Trade Name: SOMATULINE DEPOT

Generic or Proper Name: Lanreotide Acetate

NDA 022074/S-004

SUPPLEMENT APPROVAL

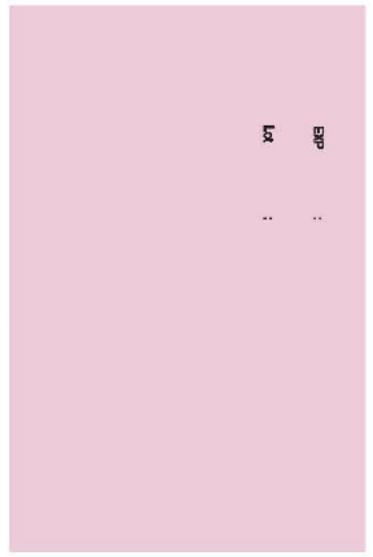
3. The instruction “Tear Here” has been added above the perforated line below the red arrow, just above the NDC number/bar code.
4. The colored illustration below the NDC number/bar code (showing how to pull the syringe open) has been removed.

Figure 2: Four Primary States of the Product

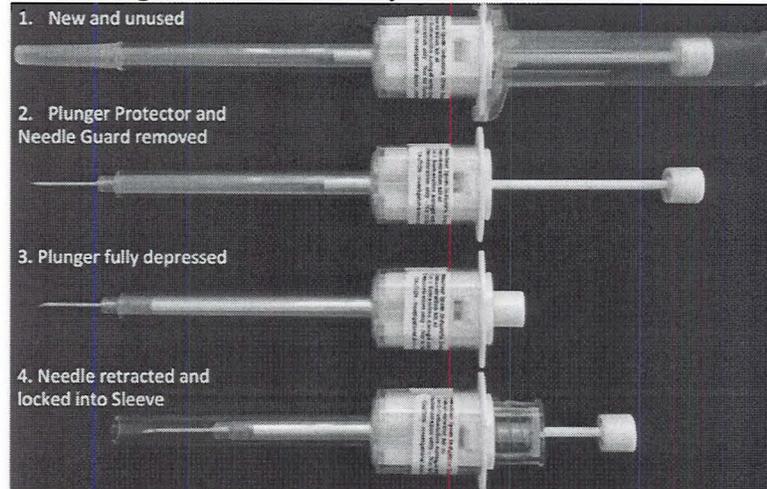
2. We note that the proposed plunger protector appears to be part of the syringe, and the plunger can be depressed with the plunger protector in place. As such it may be difficult for the user to identify that the plunger protector needs to be removed prior to administration of the injection. We recommend adding a statement or a marking on the plunger protector that prompts the user to remove it prior to use. Alternately the plunger protector can be redesigned such that the plunger cannot be reached without the removal of the plunger protector (as seen in the current design of the marketed product).
